### MAINTENANCE

SPINDLE & SEALS KIT 1112629700 for TANKFLY™ butterfly valve Flanged & Clamped

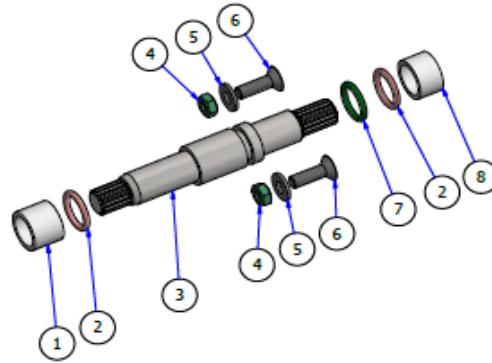
If you want to upgrade a hexagonal spindle to a splined spindle, please order spindle & spindle seals kit 1112629700, handle kit 1114854000 and closure plate kit 1285578100

ITEM	QTY	DESIGNATION	PART N°
<b>Spindle &amp; Spindle Seals kit:</b>			<b>11 12 62 97 00</b>
6	2	Screws M6-20	-
5	2	Washers	-
4	2	Nuts	-
1	1	Spindle bush, PTFE & glass 25%	12 85 30 00 03
8	1	Short spindle bush	11 12 62 00 01
2	2	O'ring, FEP & silicone	70 10 15 00 12
7	1	O'ring, FKM/Viton (Green)	70 10 01 02 12
3	1	Spindle, 1.4462	12 85 57 00 23
